1. New Primary School in Mulgoa Rise – 1-23 Forestwood Drive – Glenmore Park

ptc. has been engaged by Richard Crookes Construction on behalf of School Infrastructure NSW (SINSW) to address comments received following the submission of the State Significant Development Application (SSDA) for the proposed development of a new primary school located at 1-23 Forestwood Drive in Glenmore Park. The Transport and Traffic Assessment dated 20 August 2021 and submitted as part of the SSDA was prepared by **ptc.**

2. Council Comments

Figure 19 – HRV Swept Path at proposed Zebra Crossing at Forestwood Drive

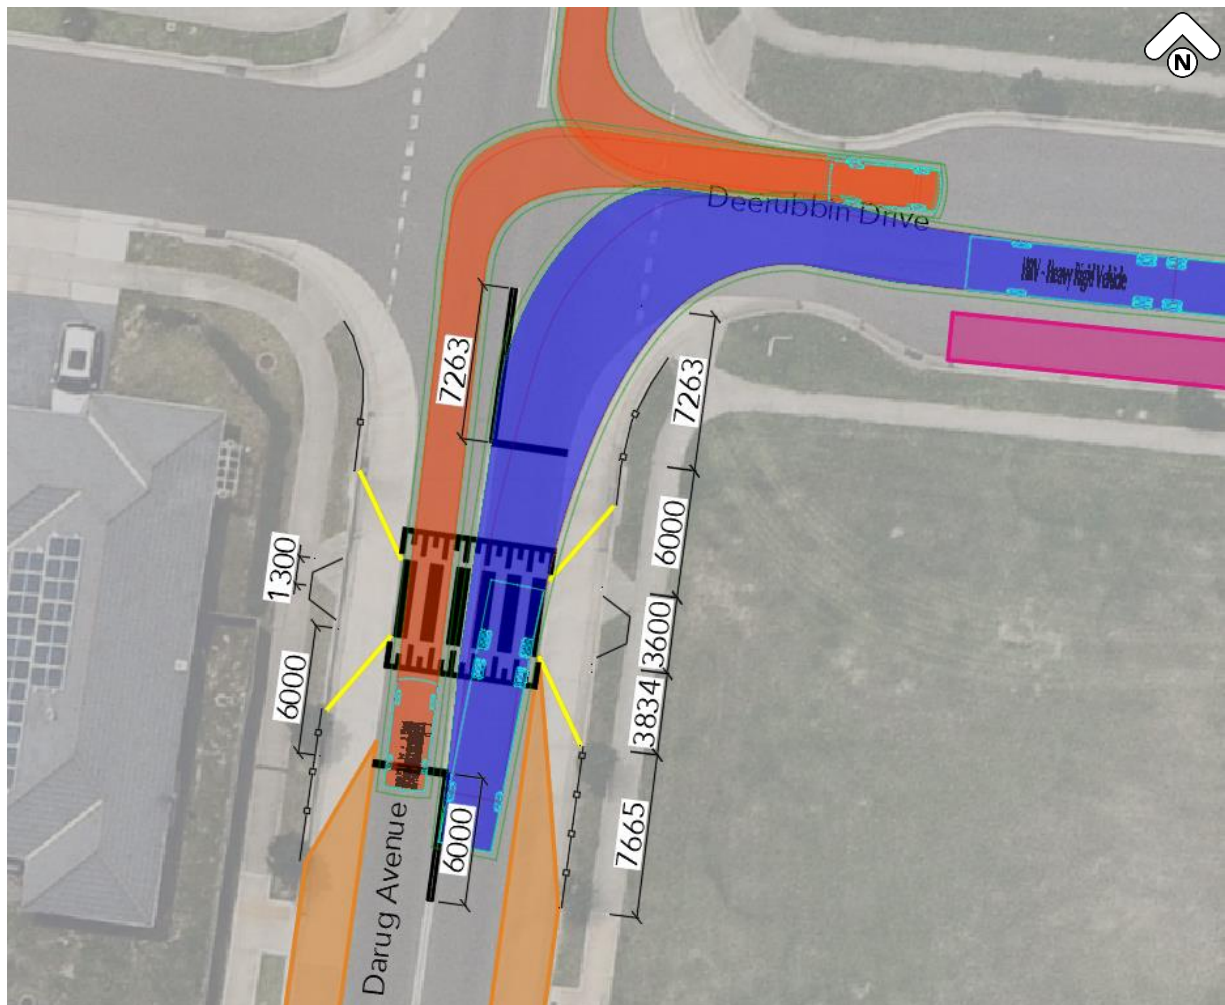
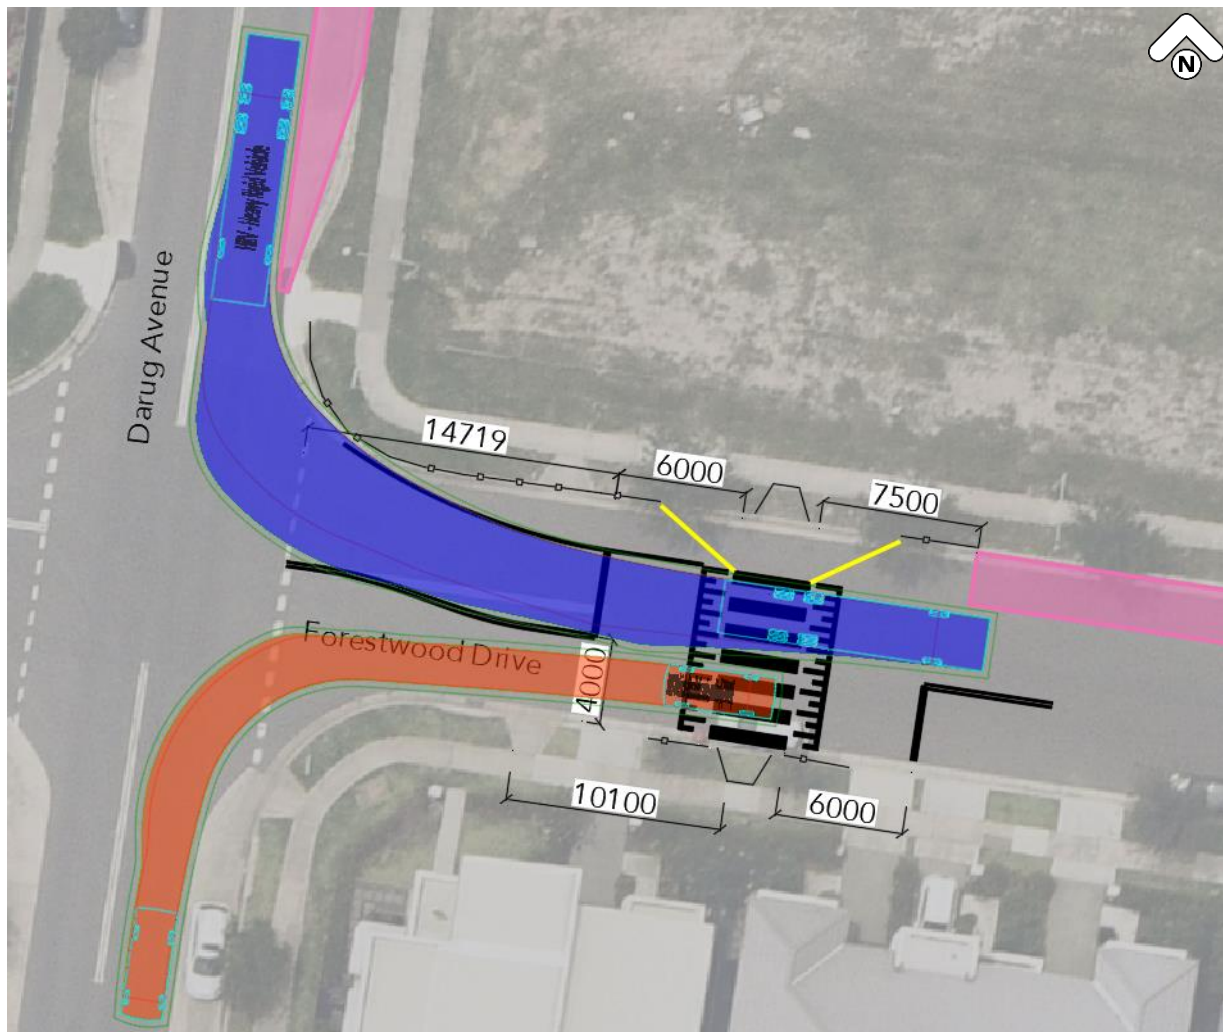
Figure 56 & Attachment 2 (Pedestrian Crossings) – The swept path is considered unacceptable (particularly due to the proximity to the pedestrian crossing), the plans indicate that a HRV encroaches over the centreline into the opposing traffic lane on both Darug Avenue and Forestwood Drive. This would result in a B99 vehicle travelling along Forestwood Drive to be forced to occupy the very left of the carriageway which is unrealistic if the vehicle is wishing to travel straight or turn right (and arrives before the HRV);

The proposed zebra crossing at Darug Avenue has been relocated further south and is located at 13.3m south of Darug Avenue / Deerubbin Drive intersection. The HRV turn movement swept path has been re-run and it can be accommodated without crossing the opposite lane, as shown in Figure 19.

The proposed zebra crossing location at Forestwood Drive has been relocated further east at 20.7m from the Darug Avenue / Forestwood Drive intersection. The proposed new location allows for adequate turn movement as shown in Figure 20.

In any case, it is noted that local roads seldomly allow for an HRV movement without crossing into the opposite lane. Further, the turn movements discussed above are not likely to occur during the pick-up and drop-off time, as no bus routes run along these routes and waste collection will occur outside of pick-up and drop-off times.

Figure 22 – Sight distances as loading area access

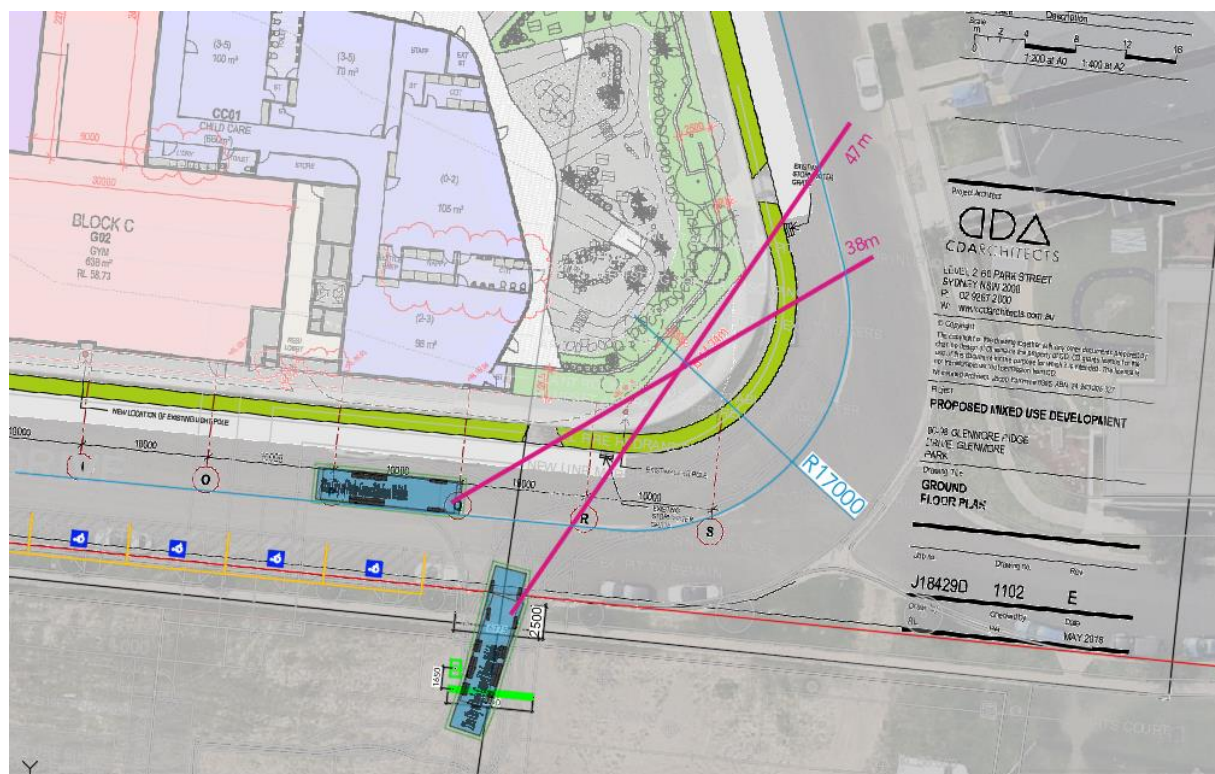
Attachment 2 (Car Park Design review ptc-004) – right turn movements into car park should be reviewed as to whether sight distance to oncoming vehicles from north is sufficient. Parking spaces adjacent to driveway should also be removed to enable sight distances for vehicles leaving the driveway;

From this formula, it has been calculated that a suitable SSD for the driveway would be 17m. With a speed of 30km/h, a sight distance of 20m is required.

Figure 22 shows the 38m and 47m unobstructed sight distance lengths starting at the drivers' location upon exit and entry to the loading area. The provided sight distance is deemed acceptable, given that 17m would be the minimum required based on the expected speed.

Figure 24 – Future Masterplan

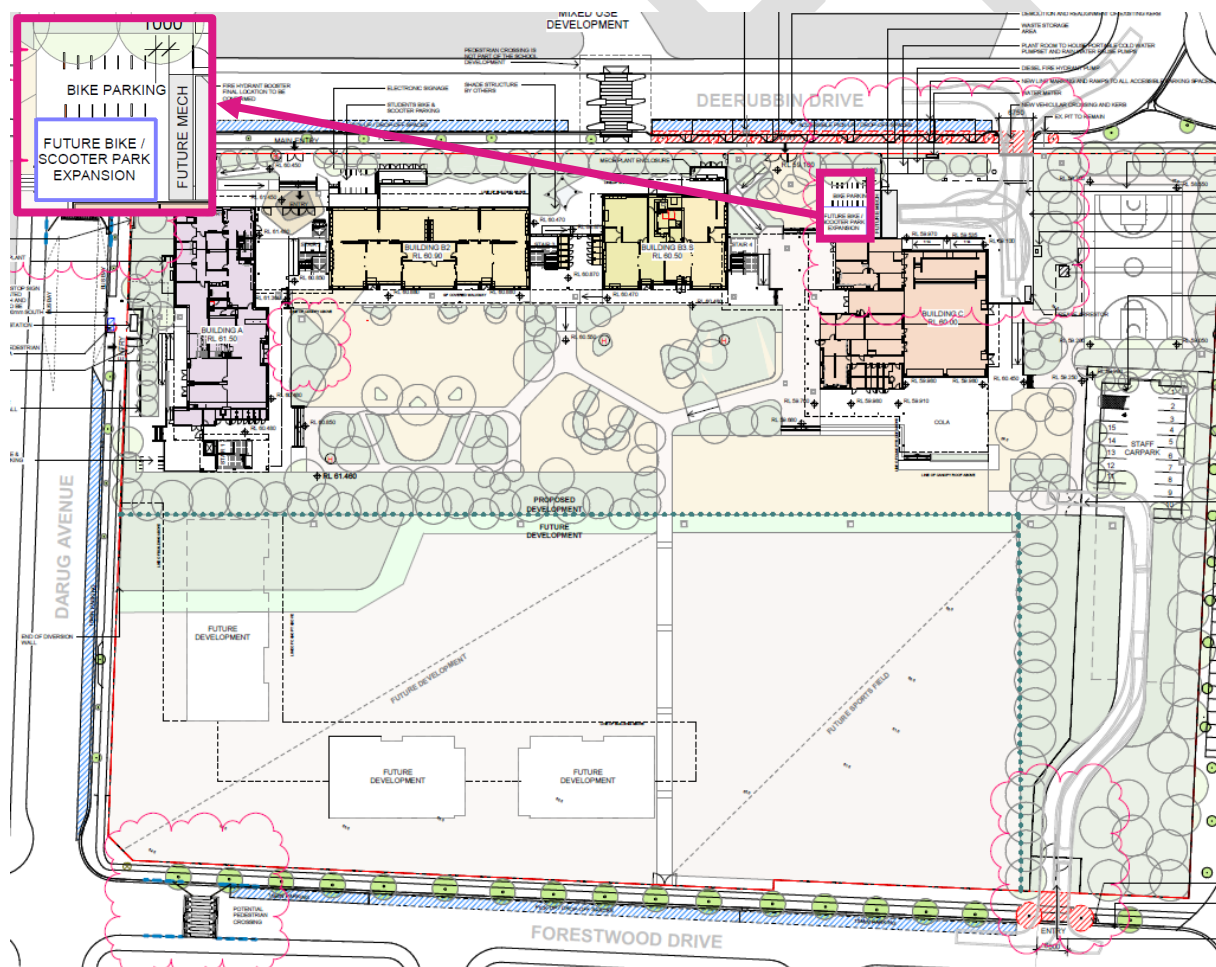
Consideration could be made to the opportunity to provide vehicle and e-bike charging station at the site as these modes of vehicles becomes more popular;

The proposal is to provide bicycle and scooter parking for 35% students for the proposed school population of 414 students. As marked in pink square in in Figure 24, the proposed development includes space to accommodate additional bike / scooter parking spaces if the demand increases.

The layout of the future school expansion has been master-planned on the southern side of the development as shown. Detailed drawings showing bicycle spaces will be prepared in due course, when the consecutive stage will be planned. However, the master plan shows vacant space where additional bicycle and scooter spaces can be accommodated.

Figure 25 – AV Swept Path at Bradley Street / Darug Avenue intersection

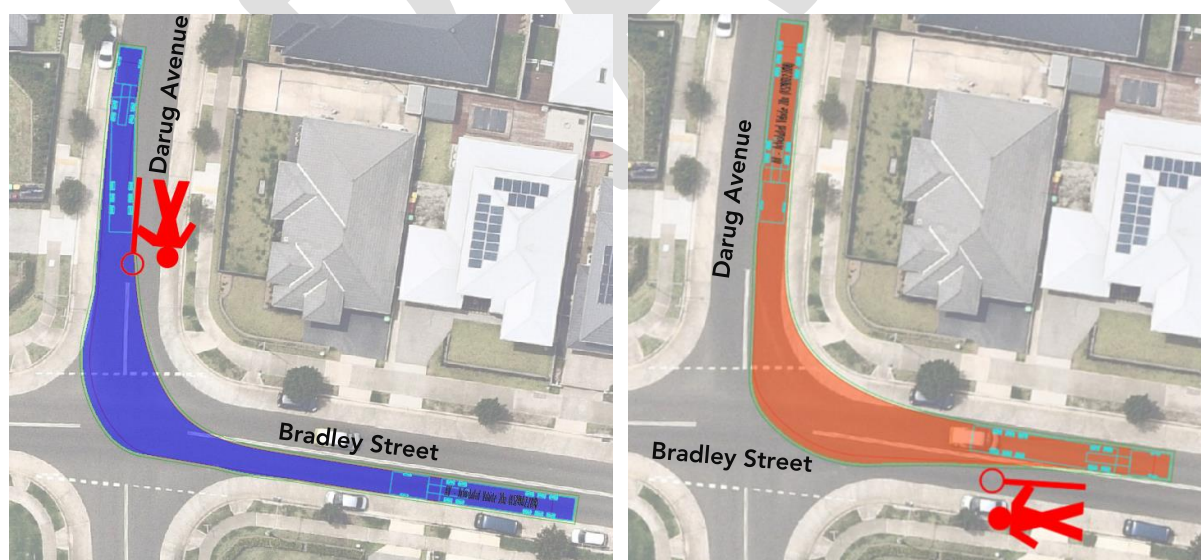
5.6.2 / Figure 24 – Truck turning right requires to occupy the left side of the road, however it is still required to give way to vehicles travelling eastbound. This will cause issues as the truck would either be obstructing the entire westbound carriageway as it waits for an appropriate gap, or the left side of the road, which causes further issues for other traffic navigating this intersection. Traffic would be required to be controlled on all legs, as truck coming out of Darug Avenue is required to still give way to vehicles travelling east along Bradley Street. This arrangement is not supported and TfNSW requests that smaller construction vehicles are used to improve safe outcomes for road users.

The Bradley Street / Darug Avenue intersection discussed in the preliminary CTMP has been shown to accommodate 2 trucks travelling simultaneously. Based on the TfNSW comment, it is proposed that these two turn movements do not overlap, which can be controlled by traffic controllers.
